DATE: 03.13.2019
TO: ProTrak
FROM: Mitesh Baxi
Traffic Engineering

■ **DISCOUNT TIRE NCC39 [TRC Plan Review]**

↻ Initial Review Note ↻

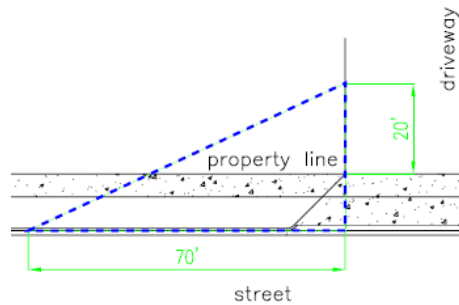
1. Driveways shall be City-standard ramp-type driveways. [SD 3-03.3 & 3-03.4 (Vertical curb) CofWTSSM].
2. Dimension driveway flares.
3. Provide curbing detail SD 3-11 on the plan. [Sec. 18-529(b)(2) CofW LDC]
4. Show and apply the City's 20'x70' sight distance triangle as per below image at each driveway on the site plan and landscaping plan. [Sec.18-529(c)(3)CofW LDC] [Sec. 18-812 CofW LDC].
